## CONSULTANCY STRUCTURAL ENGINEERING REVIEW

SUTTONS BEACH PAVILION 1

MORETON BAY REGIONAL COUNCIL (RFQ No. WP195412)

REPORT No: 62015RPT

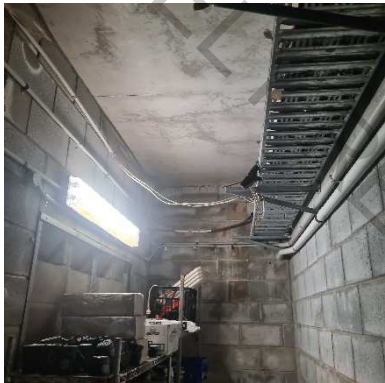
Observation Number / Location	Photo	Description	Comment
E1.6	 <p>Figure 17 – Damaged cabinet</p>	Slight corrosion starting on the lift control cabinet.	Scrape and clean up to prevent further corrosion. Wipe down regularly to keep chemicals off.
E1.7	 <p>Figure 18- non-compliant sign</p>	Exit sign body cover missing – live parts potentially exposed.	Fitting should be replaced.
E1.8	 <p>Figure 19 – Defective lights</p>	Kitchen troffer lights cracked and broken. Should be clean room sealed for dust and vermin prevention.	Replace diffusers and/or fittings.
